Sérial: NPD-NRC-2009-134  
July 1, 2009

**LEVY COUNTY NUCLEAR POWER PLANT, UNITS 1 AND 2  
DOCKET NOS. 52-029 AND 52-030  
RESPONSE TO REQUEST FOR ADDITIONAL INFORMATION LETTER NO. 034 RELATED TO  
BASIC GEOLOGIC AND SEISMIC INFORMATION**

**Levy Nuclear Power Plant Units 1 and 2  
Response to NRC Request for Additional Information Letter No. 034 Related to  
SRP Section 2.5.1 for the Combined License Application, dated May 8, 2009**

Map Showing Varying Elevation of  
Postulated Pleistocene Shoreline Features in  
Southern Georgia and Northern Florida  
RAI 02.05.01-14 Figure 1

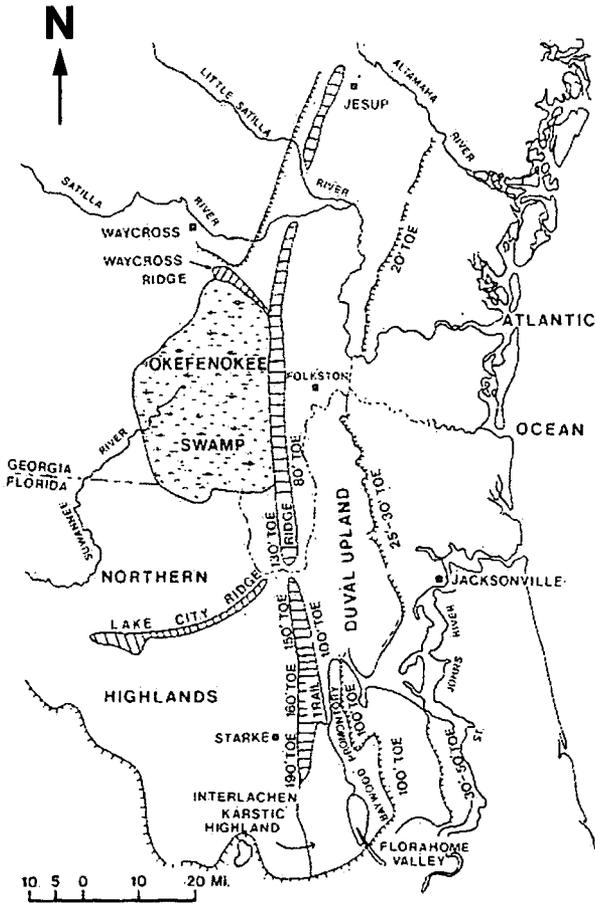
The response to RAI 2.5.1-2 indicates that Vernon (1951) attributed the regional orthogonal fracture sets to tensional stresses associated with formation of the Ocala Arch. FSAR Section 2.5.1.2.4 (pg 2.5-76) states that Vernon (1951) interpreted the arch as a plunging anticlinal fold, with the primary fracture set parallel to the axis of this structure and the secondary set perpendicular to the primary set. FSAR Section 2.5.1.2.4 (pg 2.5-76) also states that this regional fracture system is expressed at the surface by lineaments. Vernon (1951) defines the regional fracture system as two orthogonal fracture sets, spaced 30-50 km (20-30 mi) apart, which are parallel and perpendicular to the axis of the Ocala Arch and which control stream drainages and sinkhole alignments. Considering orientation of the two regional fracture sets in relation to the axis of the arch as defined by Vernon (1951), these features could be release (i.e., parallel to the axis of the Arch) and extension (perpendicular to the axis) fractures developed across the uplift. The FSAR does not clearly define orientations of these two orthogonal fracture sets (e.g., as contoured maxima on stereonet plots), but a relationship to the Ocala arch as interpreted by Vernon (1951) suggests an origin related to bending of rock units across the arch.

The response to RAI 2.5.1-2 points out that Lafrenz (2003) suggested two episodes of uplift occurred to create the Ocala Arch, the first during Late Oligocene-Early Miocene time (i.e., mid-Tertiary) and the second in Early Pliocene-Early Pleistocene time (i.e., post-Miocene neotectonic uplift during Late Tertiary-Early Quaternary). In addition, FSAR Section 2.5.1.2.1.3.1 (pg 2.5-62) states that Early Miocene "structural adjustments" of the crust associated with formation of the Ocala feature continued, with regional fracturing significantly affecting karst activity. Consequently, information presented in the FSAR suggests that tectonic uplift may have produced the Ocala Arch and the associated regional joint patterns, with deformation extending into Quaternary time. FSAR Section 2.5.1.1.4.3.5 (pg 2.5-43) discusses Quaternary tectonic structures, but does not address the interpretation of Lafrenz (2003) which suggests that Quaternary tectonic deformation was involved in development of the arch.

FSAR Section 2.5.1.2.4 (pg 2.5-76) also states that the Ocala platform was produced by sedimentary processes rather than uplift as Vernon (1951) suggested. However, this section further indicates that bedding in Tertiary units dips southwest and northeast along the flanks of the feature and northwest and southeast along its plunge, suggesting uplift with deformation of bedding. It is not clear why, if development of the feature is related strictly to sedimentary processes, dips of bedding on the limbs and along the hinge line of the feature show variations which suggest at least a gentle uplift (i.e., a broad doming) of the sedimentary units.

Their assumption was that the presence of land during these times indicated uplift. The work by Williams et al. (Reference RAI 02.05.01-14 03) was done prior to the publication of significant sea level curves for the Cenozoic, and did not take sea level fluctuation into account as a cause of erosion. The Lafrenz et al. (and Williams et al.) arguments/assumptions for tectonic uplift based only on indirect (fossil) evidence without considering erosion caused by sea level change are not considered to be well supported.

Magnetic Anomaly Map of the Florida Platform Region with Aeromagnetic Map of Taylor et al. (1968)  
 RAI 02.05.01-16 Figure 02

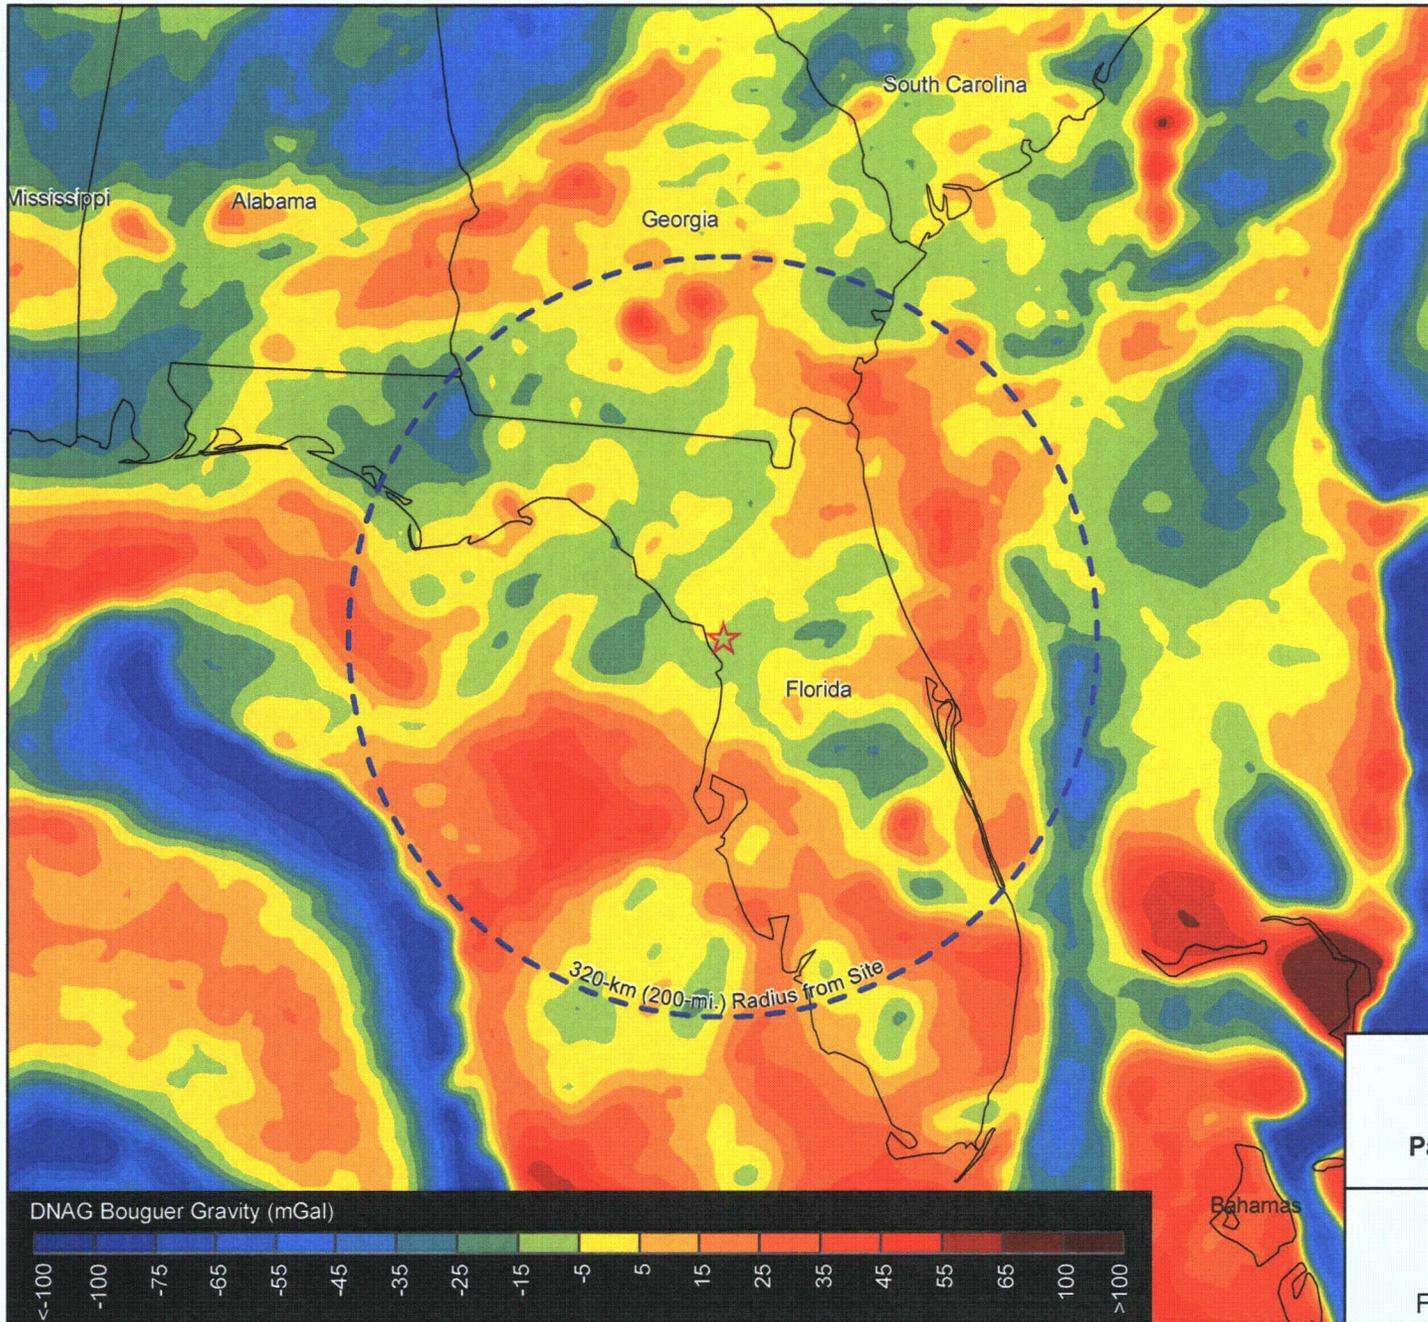
FSAR Section 2.5.1.1.4.3.1 (pg 2.5-35) states that the Jay fault was recognized by Barnett (1975) based on truncation of northwest-trending magnetic anomalies which dominate the northern part of the Florida peninsula. FSAR Figure 2.5.1-220 shows that this fault is coincident with the Florida lineament. FSAR Figure 2.5.1-220 also illustrates that the magnetic anomalies which intersect, and appear to be truncated by, this fault trend northeast rather than northwest. The fault itself trends northwest across the Florida peninsula.

In order for the staff to assess the Jay fault, please clarify the statement that northwest-trending magnetic anomalies are truncated by this structure when Figure 2.5.1-220 does not appear to show this relationship.

RAI 02.05.01-16 Figures 1 and 2 (see Attachments 02.05.01-16A and 02.05.01-16B) show the location of the postulated basement faults of Barnett (Reference 2.5.1-239) and others (Reference 2.5.1-223, Reference 2.5.1-225, Reference 2.5.1-226, Reference 2.5.1 227) relative to aeromagnetic anomaly maps of Taylor et al. (Reference RAI 02.05.01-16 01) and NAMAG (2002) (Reference 2.5.1-256), respectively. The postulated basement faults mapped by Barnett follow the northwest-trending anomalies south of the northernmost of the faults transecting the Florida peninsula rather than the northeast-trending anomalies in the northern part of the Florida peninsula.

Cenozoic Regional Tectonic Features  
 RAI 02.05.01-18 Figure 1

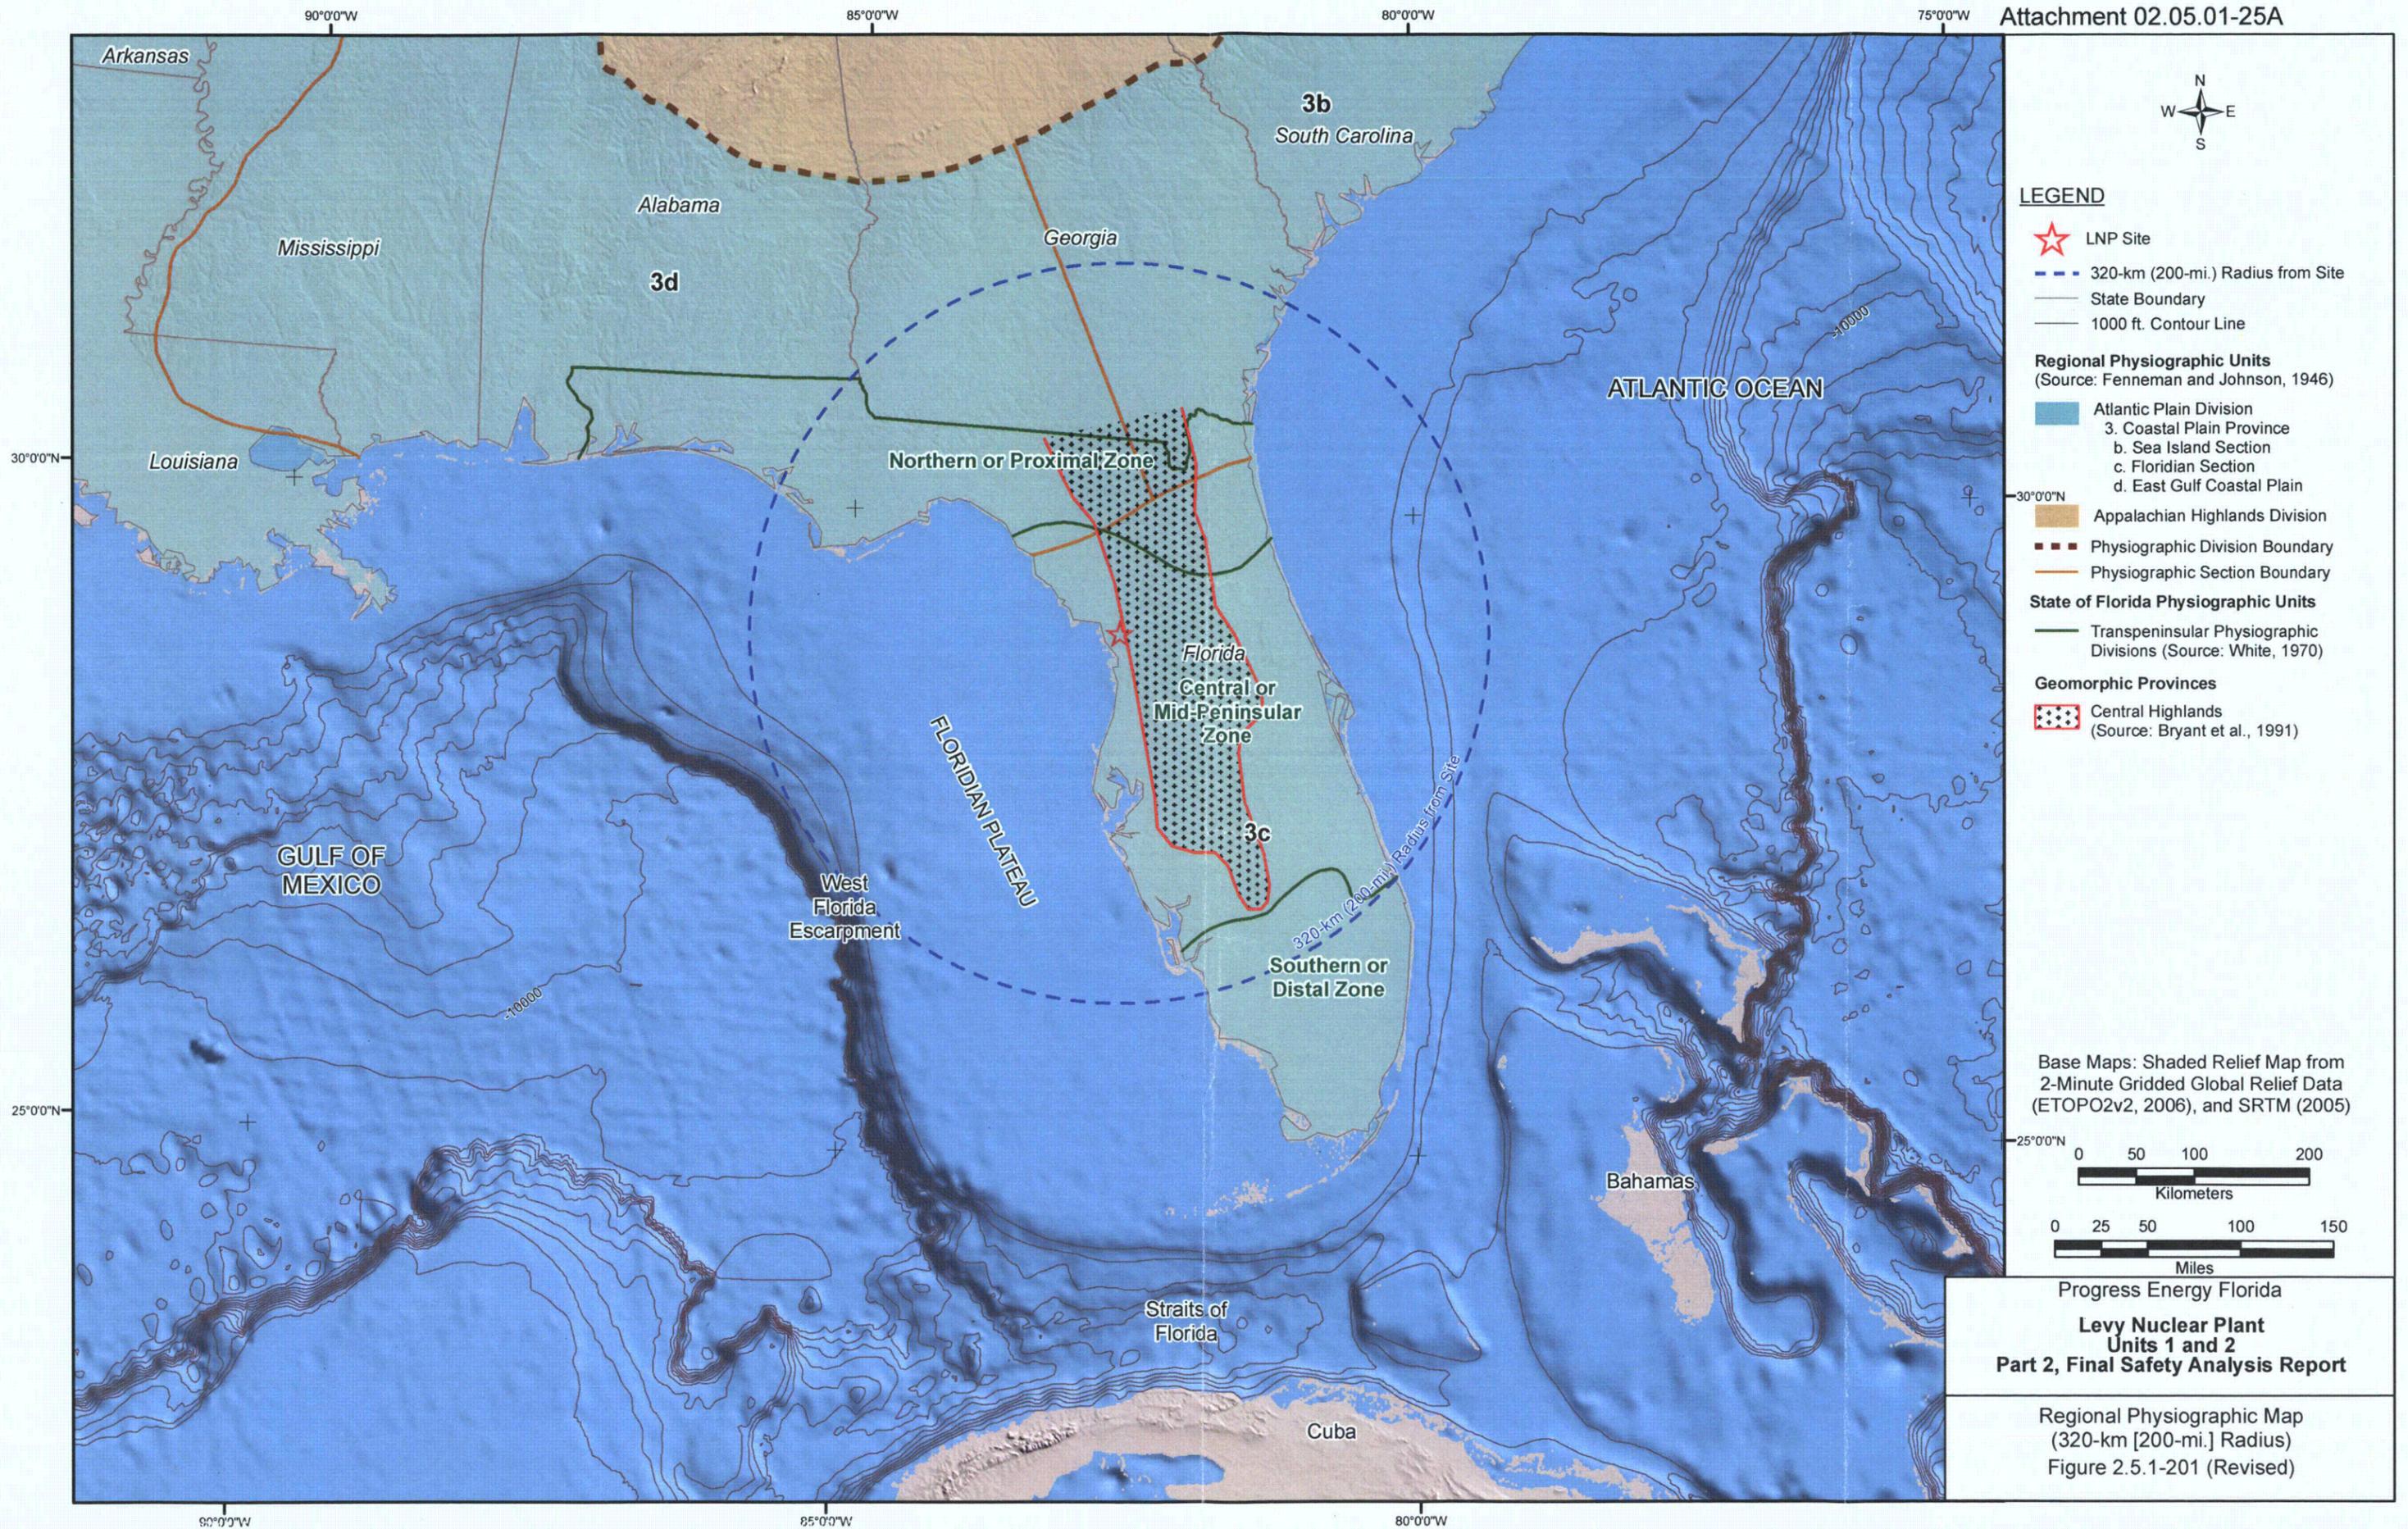
FSAR Section 2.5.1.1.4.3 (pgs 2.5-34 through 2.5-43) describes regional tectonic structures within 320km (200mi) of the LNP site, and states that FSAR Figures 2.5.1-208 and 2.6.1-209 illustrate locations of the principal tectonic features described. However, neither of these figures appear to show locations of the Bahamas fracture zone (Figures 2.5.1-207, 2.5.1-212, and 2.5.1-222 do), the Sunniland fracture zone (Figures 2.5.1-212 and 2.5.1-222 do, and Figure 2.5.1-209 shows a Sunniland arch), the Florida Elbow fault (Figure 2.5.1-222 does), the postulated fault of Applin and Applin, the Suwannee-Wiggins suture (Figure 2.5.1-211 does, but Figure 2.5.1-208 shows a Wiggins uplift and Figure 2.5.1-209 shows a Wiggins arch), the South Georgia rift (Figure 2.5.1-204, and maybe 2.5.1-206, do), the Brevard platform, the Gulf trough (Figure 2.5.1-224 does, seemingly in the area of the South Georgia rift), the Jacksonville basin, the Nassau nose, the Okeechobee basin, the Osceola low, the Sanford high, the St. Johns platform, and the Suwanee strait.

Figure 2.5.1-209 will be revised to show Paleozoic and Mesozoic structures. RAI 02.05.01-18 Figure 1 will be added to show Cenozoic structures. Figure 2.5.1-222 will be revised to label the North Providence Channel fault and to show the Jay fault.
